Access Compliance Report

Public Rights-of-Way

(Curb Ramps)

Intersection ID: 13833	Main Street: WEST_BV	Cross Street: WALTON_RD	Location: NE
ADA ID: 74CC9AB26AD6	Ramp Type: PerpDiag	Initial Pass/Fail: Pass	Overall Compliance: No
		Severity Score: 7.5

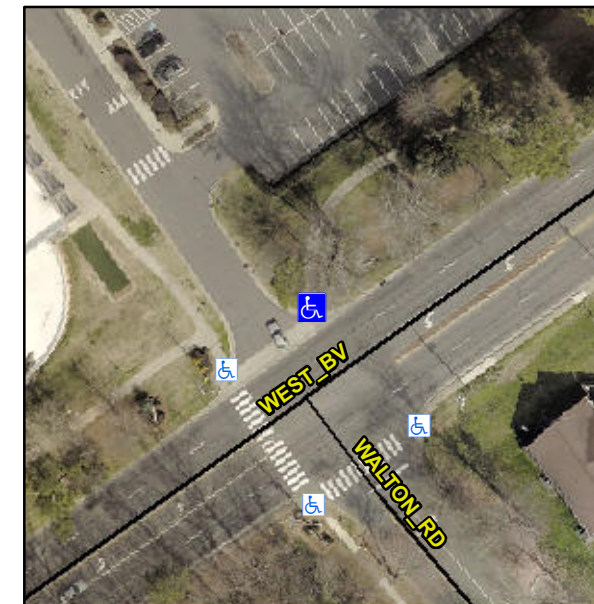
**R304.2.1, R304.2.2-Perp, R304.3.2-
Para, R302.7.2, R304.5.3**

Compliance	Description	Data	Compliance	Description	Data
N/A	Ramp Length (in)	26.0	Yes	Ramp Slope (%)	7.5
Yes	Ramp Width (in)	48.0	Yes	Ramp XSlope (%)	1.9
N/A	Flare Type LT	Sloped	N/A	Flare Type RT	N/A
N/A	Flare Slope LT (%)	5.4	N/A	Flare Slope RT (%)	4.4
N/A	Flare Traversable LT?	No	N/A	Flare Traversable RT?	No
Yes	Landing Length (in)	71.0	Yes	DWS Provided?	Yes
No	Landing Width (in)	47.0	Yes	DWS Contrast?	Yes
No	Landing Slope (%)	2.5	Yes	DWS Length (in)	24.0
Yes	Landing X Slope (%)	1.4	Yes	DWS Full Width?	Yes
N/A	Landing Curb? (Y/N)	No	Yes	DWS Offset (in)	1.0
N/A	Shared Landing?	No			
Yes	Gutter Ponding?	No	Yes	Gutter Slope (%)	1.4
No	Gutter Lip Ht (in)	0.5	No	Gutter X Slope (%)	2.5
N/A	Painted X Walk1?	No	N/A	Painted X Walk2?	No
	X Walk 1 Direction	To SW		X Walk 2 Direction	To SE
N/A	X Walk 1 Width (in)	N/A	N/A	X Walk 2 Width (in)	N/A
	X Walk 1 Slope (%)	1.7		X Walk 2 Slope (%)	1.7
	X Walk 1 X Slope (%)	3.4		X Walk 2 X Slope (%)	2.4

N/A	Ramp inside XWalk1?	N/A	N/A	Ramp inside XWalk2?	N/A
	Road Slope (%)	3.6	N/A	Clear Space?	Yes
	Road X Slope (%)	1.2	N/A	Clear Space to XWalk (in)	N/A
Yes	Any Obstructions?	No	Yes	Storm Grate/Utility Hazard?	No
	Obstruction Type			Storm Grate/Utility Type	
		N/A			N/A
			Yes	Surface Condition? (G/P)	Good

**Remove & Replace Landing.
Remove & Replace Gutter.**
